CEC Efficiency Committee Workshop

Comments by Motorola Solutions, Inc.

Docket # 09-AAER-2

2010 Rulemaking Proceeding Phase II on Appliance Efficiency Regulations

Variation in battery charge efficiency

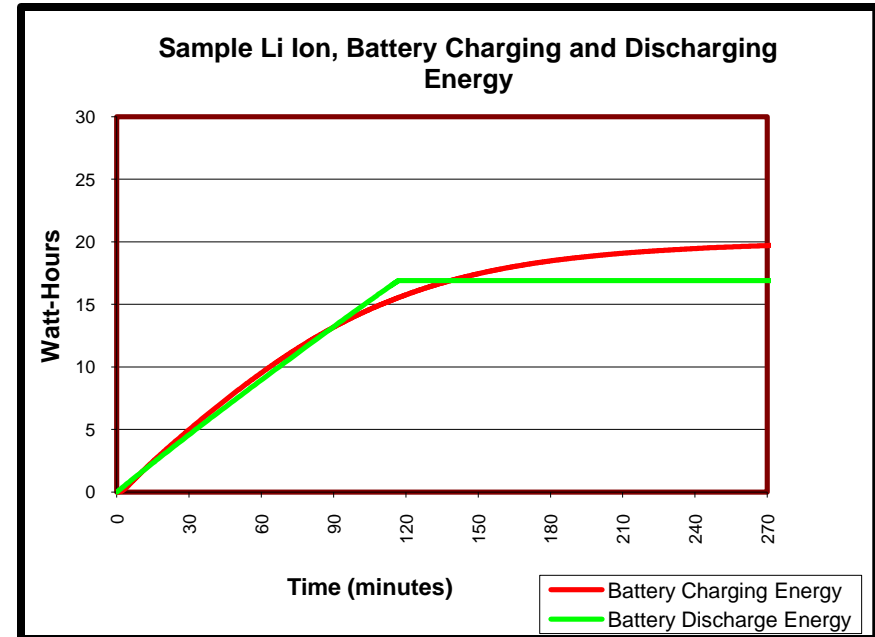
- Charge acceptance during charging is about 80% as compared with 99+% for Lithium
- Mission critical applications require Rapid Charging (1-2 hour charge time)
- Continuous maintenance charging is necessary to ensure full capacity
- Nickel batteries have a higher self discharge when compared to Lithium batteries
- Many users leave their radios in the chargers for extended periods of time
- Many users leave their radios on while in a charger

- Allow AC input energy $\leq (12 + 1.9E_b)$ when charging Nickel-based batteries
